**Historic Architectural Review Commission
Staff Report for Item 4**

Application Number: 18-0572

Address: #1419 Thompson Street

Extension of first floor rear porch and new second floor rear porch. Replacement of windows to doors at rear.

NORTH ELEVATION (EXISTING)

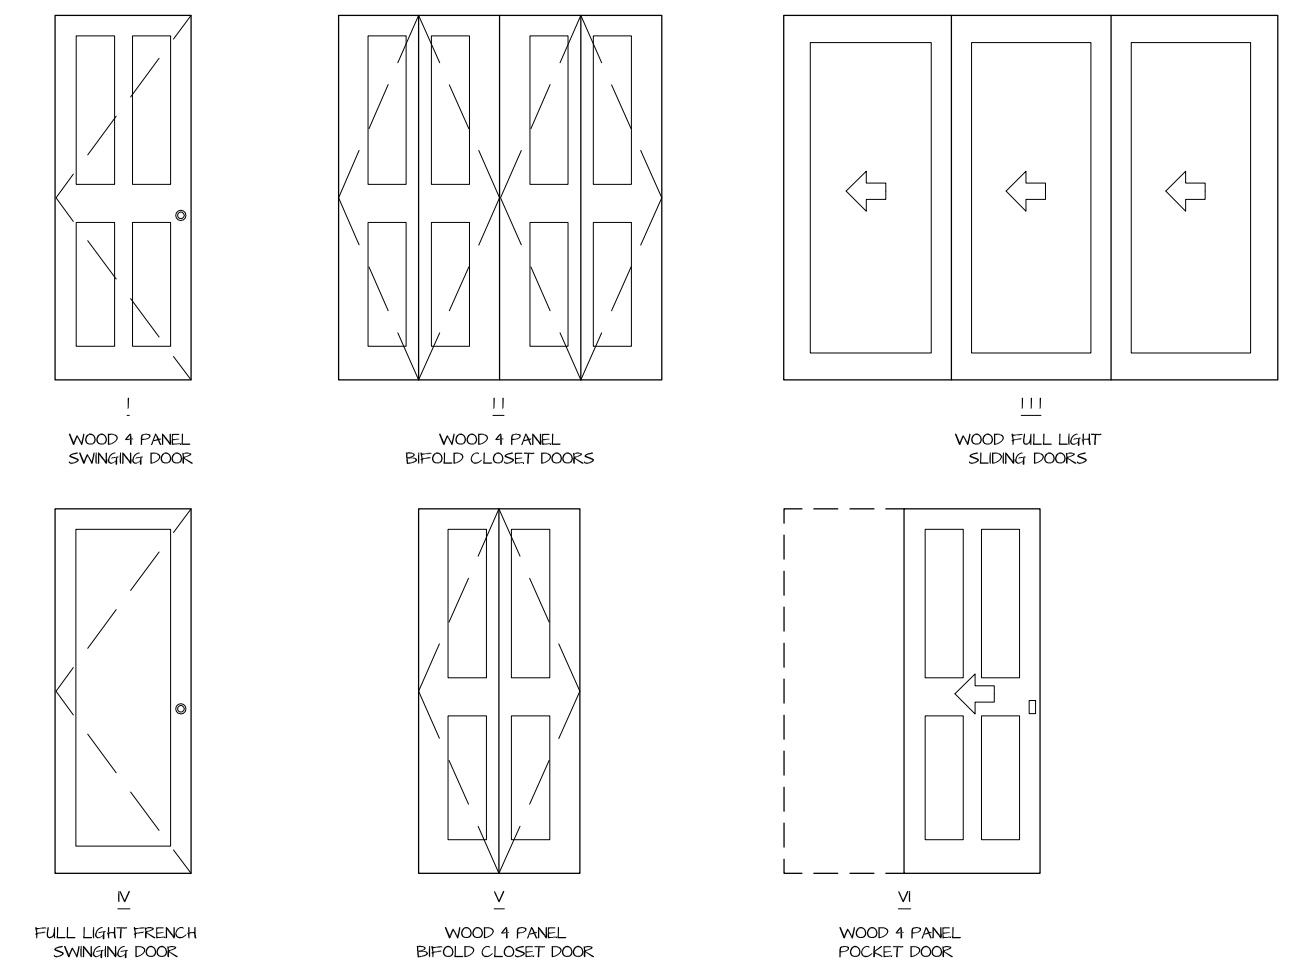
This Certificate of Appropriateness proposes adding an expanded deck and a new second floor balcony on the rear of 1419 Thompson Street. The balcony will be connected to the historic portion of the house. It will be approximately 13 feet by 12 feet. Both the balcony and the deck will be made of wood. Fenestrations on the rear of the house will be changed and replaced with fiberglass doors.

Staff believes that the proposed balcony and deck will not greatly alter or expand the massing of the historic structure, and it will not have an impact on the neighboring contributing structure at 1415 Thompson Street. Normally, additions and alterations are analyzed for their impact on the neighboring historic context and the historic district. As this structure is located outside of the historic district, that impact cannot be analyzed. Therefore, it is staff's opinion that the proposed design is consistent with the guidelines for additions and alterations.
